COUNTY OF SAN LUIS OBISPO
BOB JONES PATHWAY
(SAN LUIS OBISPO TO ONTARIO ROAD)
FINAL ENVIRONMENTAL IMPACT REPORT

SCH #2010031121

JANUARY 2015

RESPONSE TO COMMENTS

Exhibit A
DEIR Alignment

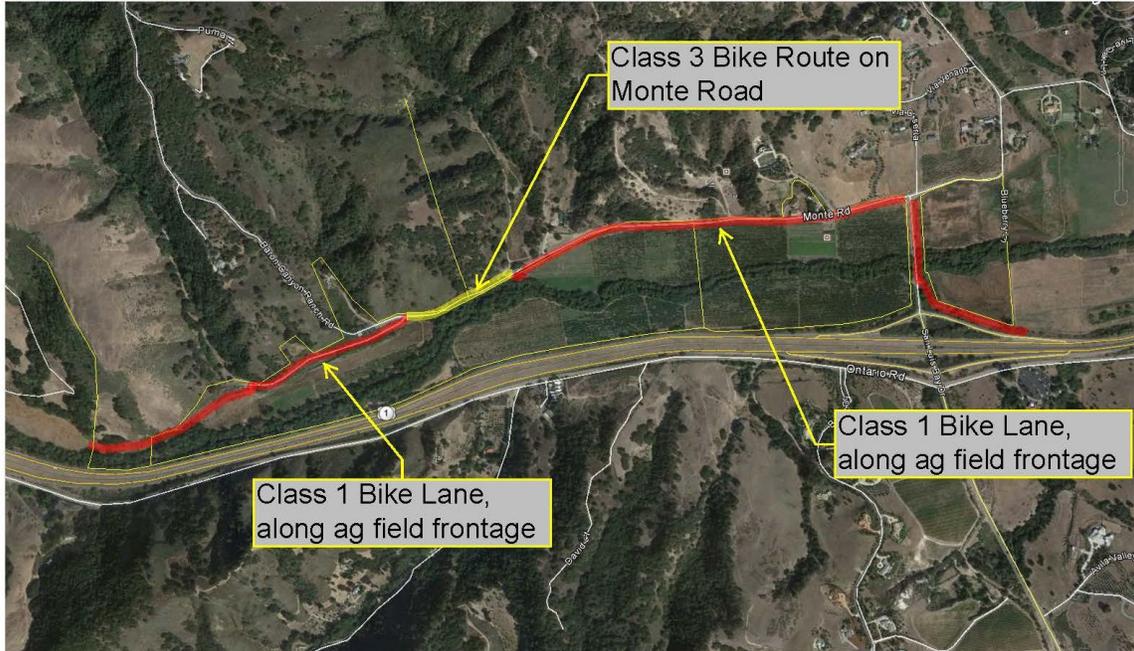
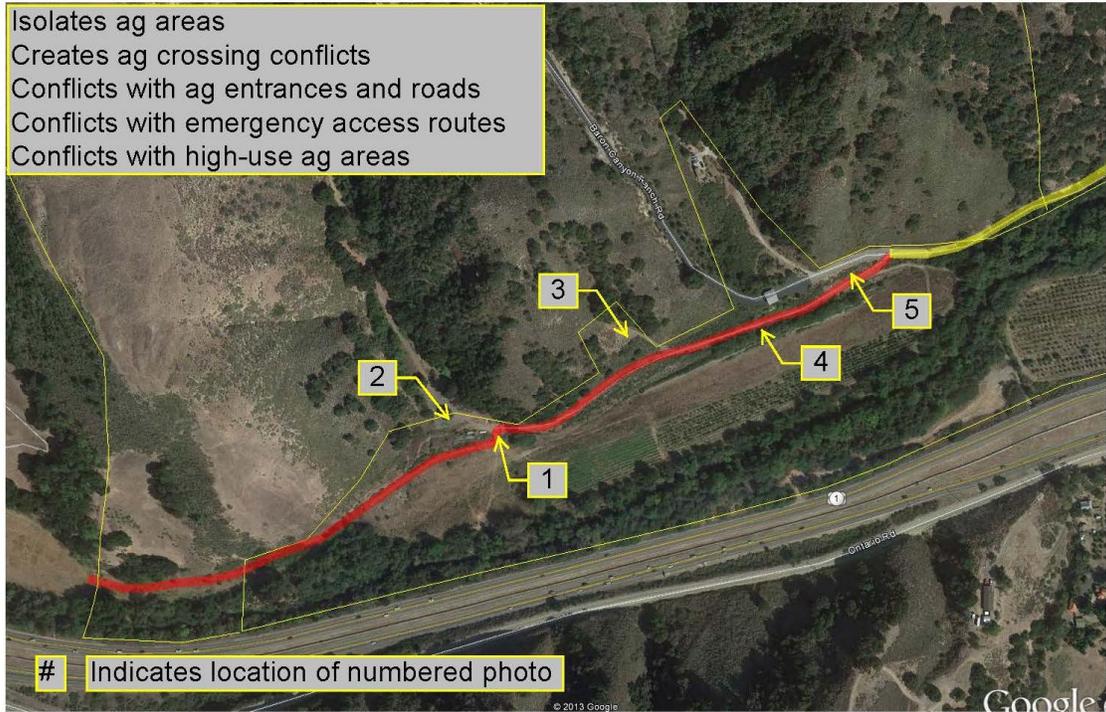
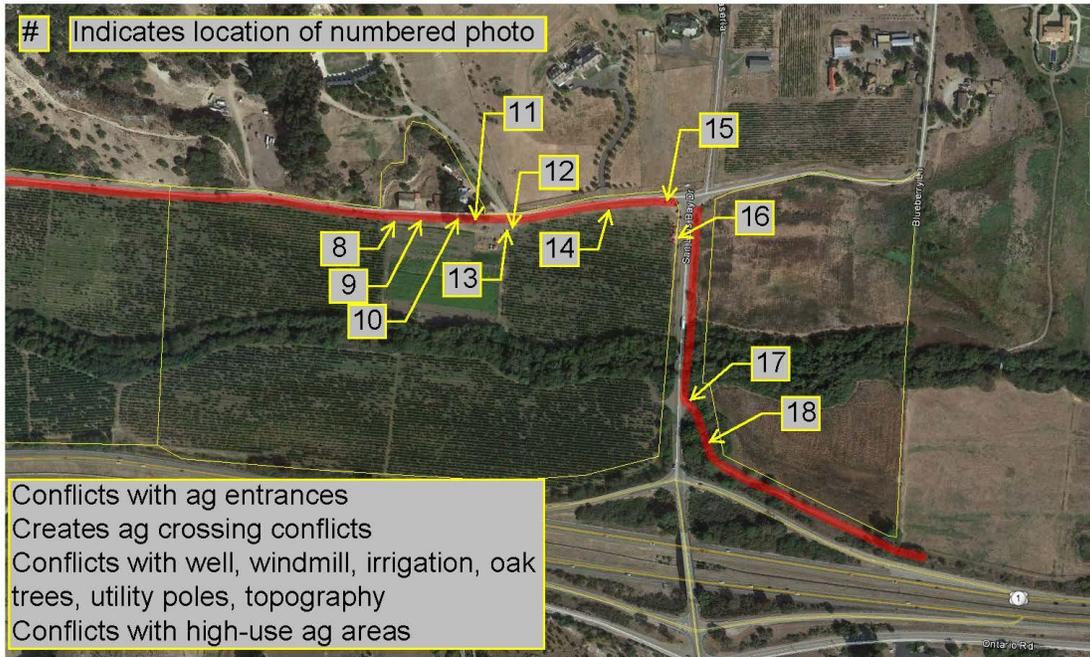
1. The DEIR proposed bike lane isolates existing agriculture use areas from the primary farm fields. In order to continue utilizing the isolated area, new agricultural crossings need to be identified on the DEIR, and all the crossing conflicts addressed.
2. In some areas, the separation means that instead of one agricultural road, two will be needed, and this is added lost use of farm land that needs to be identified as an impact, and mitigated

1. The DEIR proposed bike lane eliminates several areas of functional importance to the farming operations. These include areas used for employee parking, vehicle turning, loading and unloading, equipment storage, and irrigation.
2. The DEIR needs to identify the loss of these areas and show how and where they will be replaced. The lost areas of functionality need to be included in the area of agricultural impact and mitigated.

See Master Response 1. The RDEIR provides an analysis of Alternative 6 (Farming Operations and Conflict Avoidance), which includes an alternative alignment that would avoid Monte Road and the adjacent farming operations, thereby avoiding potential conflicts with these uses. Alternative 6 has been identified as the environmentally superior alternative. Alternative 6 incorporates several alignment and design concepts as suggested in the Farm-Friendly Alternative.
